**SUSQUEHANNA STEAM ELECTRIC STATION  
PROPOSED LICENSE AMENDMENT  
NUMBERS 289 FOR UNIT 1 OPERATING LICENSE NO. NPF-14  
AND 257 FOR UNIT 2 OPERATING LICENSE NO. NPF-22  
STANDBY LIQUID CONTROL SYSTEM  
PLA-6049**

**Docket Nos. 50-387  
and 50-388**

**PPL SUSQUEHANNA EVALUATION OF  
PROPOSED CHANGES TO  
TECHNICAL SPECIFICATION 3.7.1,  
“STANDBY LIQUID CONTROL SYSTEM”**

FIGURE 3.1.7-1

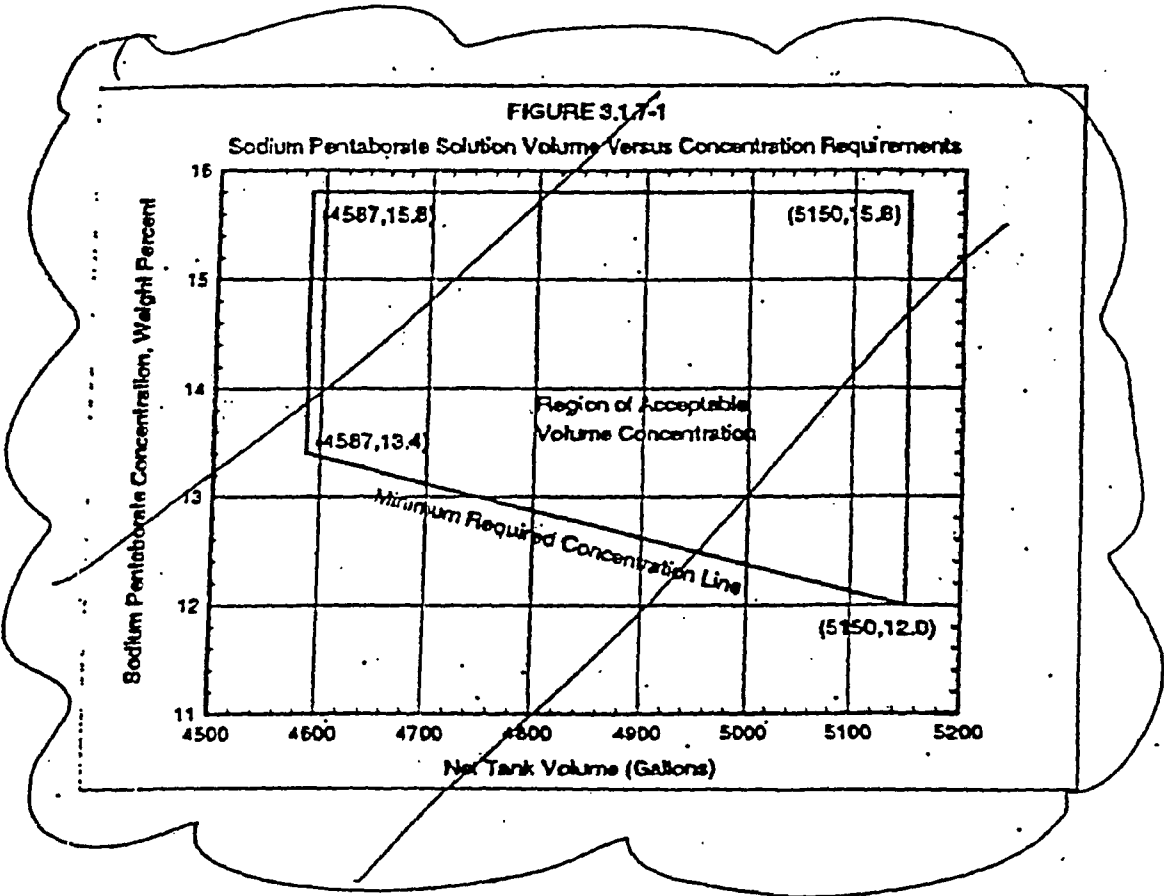
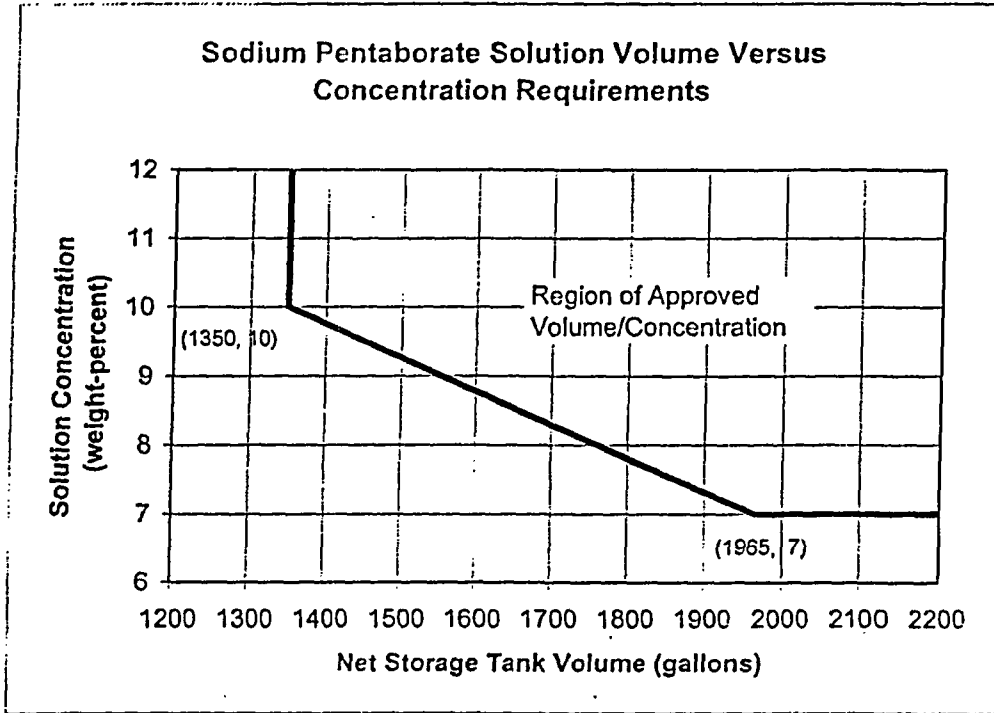
- 10) Replacement of Figure 3.1.7-1 to reflect the lower required sodium pentaborate concentration versus tank volume, which reflects the use of enriched boron.

The SLC system operation, using only one pump and with a sodium pentaborate solution with properties within the acceptance region of the new proposed Figure 3.1.7-1, will limit peak suppression pool temperature to a maximum of 206°F, which is within the SSES suppression pool design limit of 220°F.
